SERVICE BULLETIN

APPLICABILITY: 2015-2018MY Legacy and Outback

NUMBER: 12-253-18

SUBJECT: “Squeak” “Creak” or “Pop” -Type Sound from Driver’s Seat

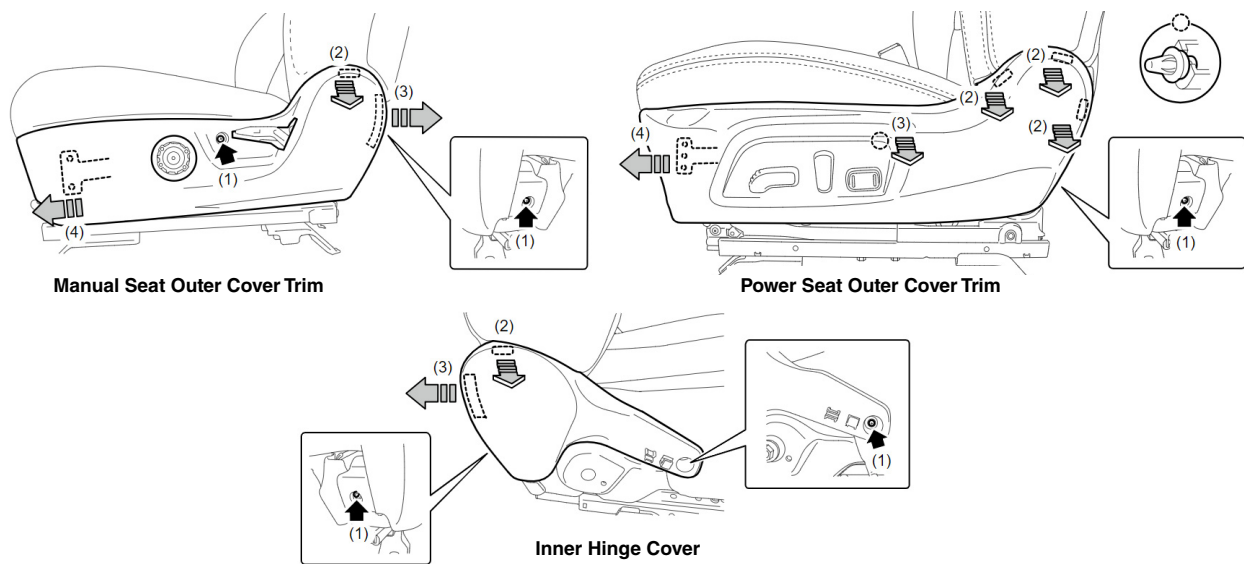
Step 1- Using a knee and body weight applied to the seat cushion, apply pressure towards the rear seat frame mounting bolts from each corner, one corner at a time while listening for the sound to occur.

Step 2- While sitting in the rear seat, apply back and forth pressure to the backrest while pushing downward toward the seat frame slide rails. Repeat this step using a twisting motion. This applies pressure to the TORX bolts and will help isolate any squeaks.

Step 3- While sitting in the driver's seat, apply pressure with feet / legs as shown towards the back of the seat while leaning and shifting body weight towards the four TORX bolts. When complete, raise the seat to the fully lifted position.

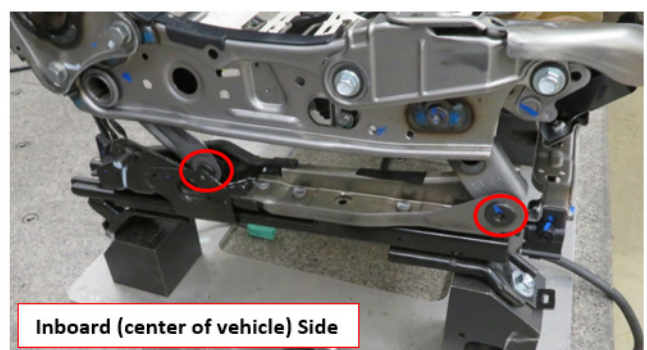
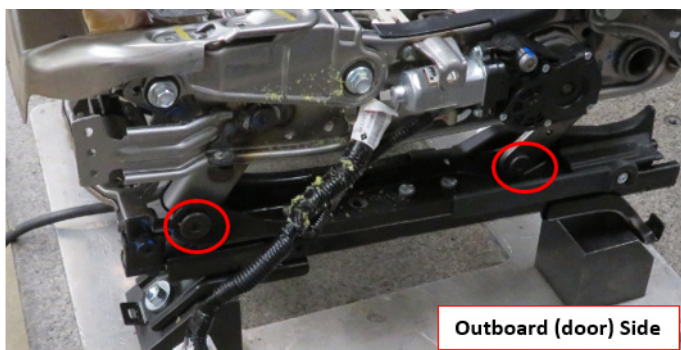
Step 5- After removing the two retaining screws (1) in the images below, **CAREFULLY** remove the inner hinge cover trim and outer seat cushion side trim panel. This will provide access to the outboard TORX bolts.

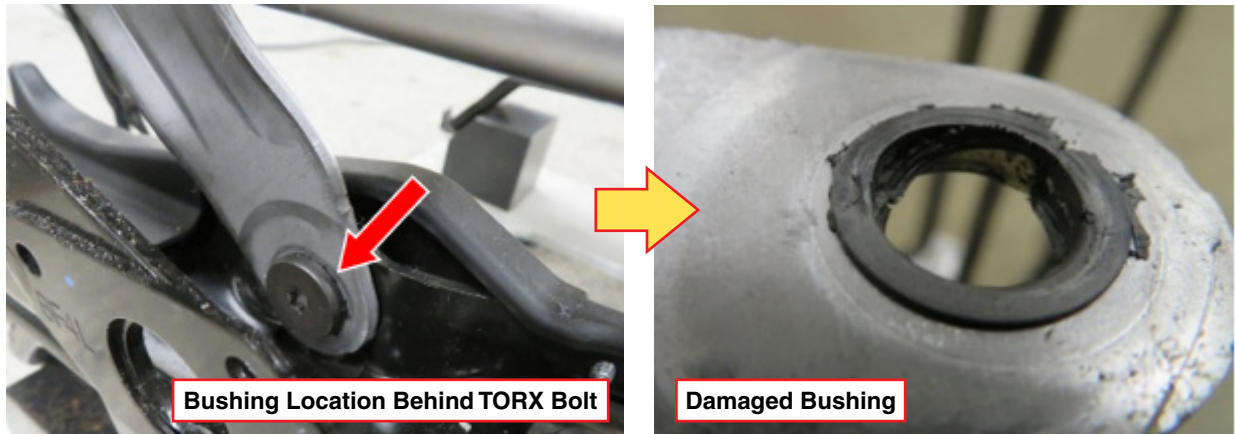
Step 6) Inspect all four of the TORX bolts closely for any signs of wear. The seat must be lifted to see all four of them.

Step 7) Remove the link bolts using a T45 TORX bit to inspect the Teflon bushing underneath for damage.

NOTE: Only inspect one side at a time. If OK, re-install the TORX bolt and retorque to 15 ± 2 Nm (11 ft. lbs.). Most damaged Teflon bushings are found on the inboard side.

If any of the four Teflon bushing(s) are damaged, replace the seat cushion frame assembly following the procedure in the applicable Service Manual.
